S/M Fix: Valve Body Replacement, '01 Civic

S/M Fix: Damper/Spring Replacement, '01 Civic

Civic '01 S/M Fixes: Restraints Troubleshooting

HONDA ServiceNews

Modify the Universal Holder

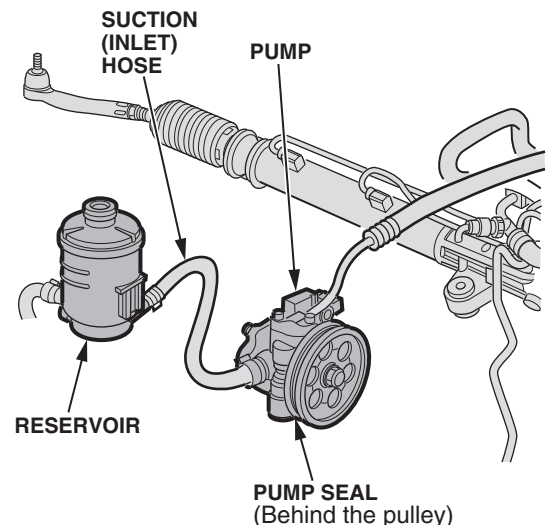
The original pins on the Universal Holder (T/N 07725-0030000) are too short to completely engage the holes in a power steering pump pulley. To improve this tool, press out the original pins, and install an 8 x 30 mm bolt into each hole.

A/C Compressor Mounting Bolts: '01 Civic

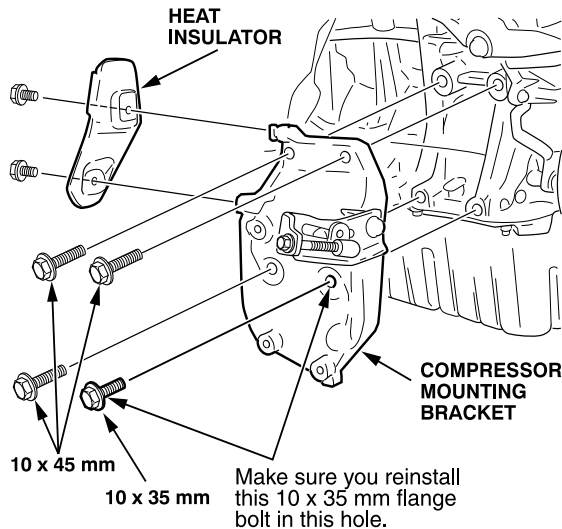
In step 17 of the '01 Civic A/C installation instruction (AII 21888-22262), you must remove the A/C compressor bracket to install the heat insulator. Three of the A/C compressor bolts are 10 x 45 mm and one is 10 x 35 mm. When you reinstall the compressor bracket, make sure you reinstall the 10 x 35 mm bolt in the *lower right* bolt hole in the bracket. If you install one of the longer 10 x 45 mm bolts in that hole, the bolt head will damage the compressor.

Pages 14-144 and 14-174: Change the Exploded Views to look like this:

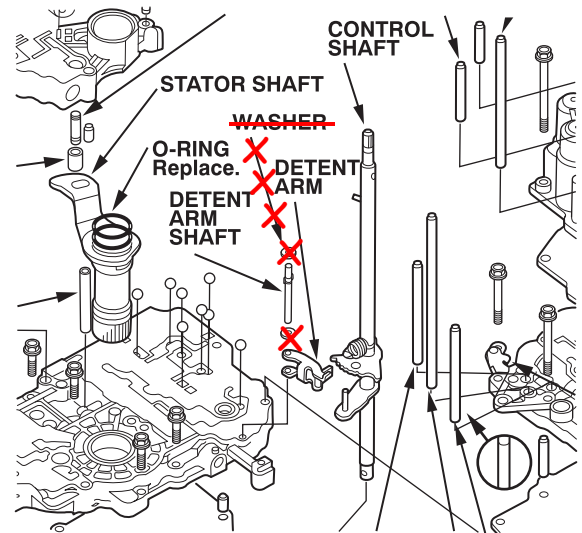
The Automatic Transmission section of the '01 Civic S/M calls out washers for the detent arm shaft. There are *no* washers used for the detent arm shaft in '01 Civics. Make these changes in your copies of the S/M:

Page 23-32: Change the circuit diagram to look like this:

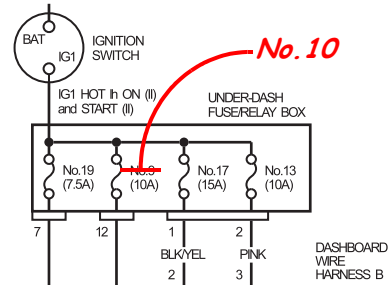
The Restraints section of the '01 Civic S/M has the wrong fuse number called out in the driver's under-dash fuse/relay box. The No. 19 (7.5 A) fuse should be No. 10 (7.5 A). Make sure you include these changes in your copies of the S/M:
